Monticello Nuclear Generating Plant
Docket 50-263
License No. DPR-22

Response to Request for Additional Information and Submittal of Additional Information
in Support of the Monticello License Renewal Application (TAC No. MC6440)

Response to Request for Additional Information Regarding the Monticello Nuclear Generating Plant License Renewal Application

BWRVIP-99: Figure 7-13. Radiation creep relaxation of shear stresses in springs of 20% cold worked 316 stainless steel along with modeling curves. The dotted line represents 0.1 dpa which is equivalent to a fluence of $\sim 6-7 \times 10^{19}$ n/cm.

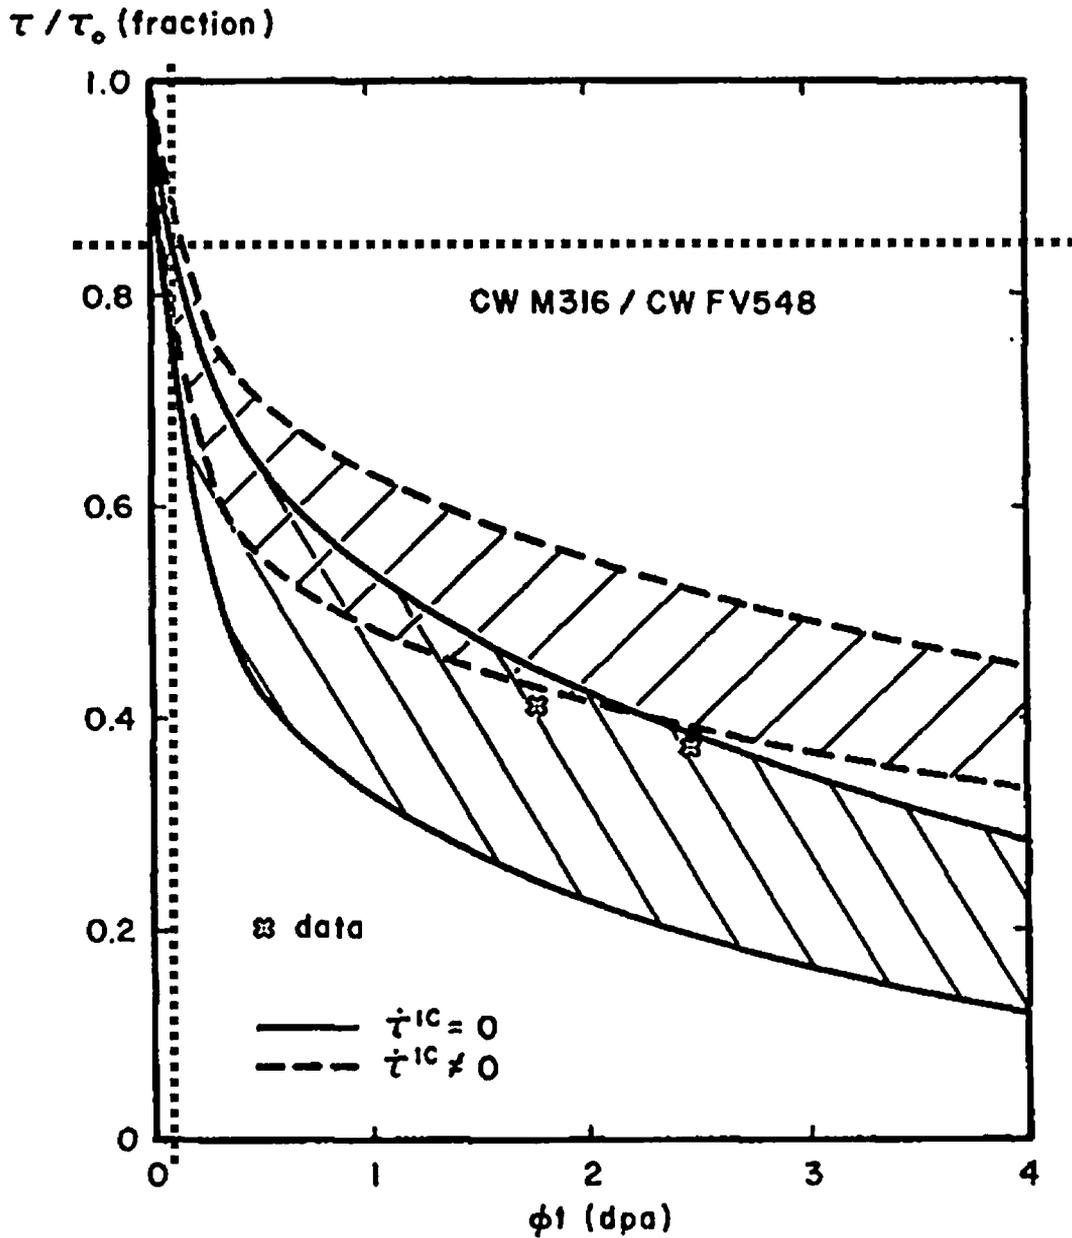
NRC RAI 4.8-1

Please provide details of your analysis and technical basis for the Time-Limited Aging Analysis (TLAA) for Stress Relaxation of Rim Holddown Bolts, Section 4.8 of the LRA.

NMC Response to RAI 4.8-1

The core plate configuration for the MNGP is identified properly in Figure 2-3 of BWRVIP-25, "BWR Core Plate Inspection and Flaw Evaluation Guidelines." Therefore, MNGP was specifically considered in the original BWRVIP-25 evaluation, incorporating typical values of temperature and fluence. An analysis was initially performed for a 40-year plant life. The analysis was later performed for a 60-year plant life as discussed in Paragraph B.4 of BWRVIP-25; Appendix B of BWRVIP-25 addresses License Renewal. BWRVIP-25 identified a range of expected stress relaxation, for a group of plants which includes MNGP, from 5 to 19% for a 60-year plant life. The MNGP Time-Limited Aging Analysis (TLAA), conservatively noted the bounding value for stress relaxation of 19% (as documented in Section 4.8 of the LRA) for the core plate bolts over the 60-year operating period.

To more accurately address MNGP for License Renewal, a plant-specific calculation was performed that incorporated the MNGP core plate geometry, an operating temperature of 288°C (550°F) and a MNGP fluence calculation that was performed specifically for License Renewal in accordance with guidance provided in Regulatory Guide 1.190, "Calculational and Dosimetry Methods for Determining Pressure Vessel Neutron Fluence," March 2001, (LRA Section 4.2.1). The maximum fluence applicable to the bolts in the highest fluence region of the core plate was determined to be 2.2×10^{19} n/cm² at the end of the 60-year plant life. The resultant relaxation was determined to be 8% based on GE Design Documents. The analysis assumed that all of the bolts were at this fluence even though many bolts experience a lower fluence depending on their specific location. This plant-specific analysis is bounded by the original application that conservatively assumed a higher value of 19% relaxation.

Confidence in the stress relaxation value that was employed can be independently confirmed using other reports available to the NRC. Specifically, stress relaxation as a function of fluence has been presented in the Section 7 of BWRVIP-99, "Crack Growth Rates in Irradiated BWR Stainless Steel Internal Components." This section deals directly with stress relaxation as a function of fluence. Figure 7-13 from BWRVIP-99 is

attached; it shows data and modeling projections of stress relaxation versus fluence in displacements per atom (dpa). One dpa is equivalent to a fluence of $6-7 \times 10^{20}$ n/cm². It is noted that the data presented in the figure was measured on Type 316 stainless steel material. Comparison with Type 304 data is considered appropriate in that the two commercial alloys have the same single-phase austenitic microstructure and crystal structure, with no precipitates present in either alloy. The only compositional difference is the addition of molybdenum (Mo) to Type 316 to increase pitting resistance. The mechanical properties are essentially identical at 288°C (550°F). Therefore, the effect of irradiation on stress relaxation for both alloys is essentially the same. Since the fluence of interest for the MNGP calculations is less than 10% of the 1 dpa equivalent fluence, dotted lines have been included on the attached copy of Figure 7-13 to depict a fluence level of 0.1 dpa which substantiates that the projected stress relaxation is less than 19%. This supports the value used in the analysis and, in turn, the GE Design Curve.
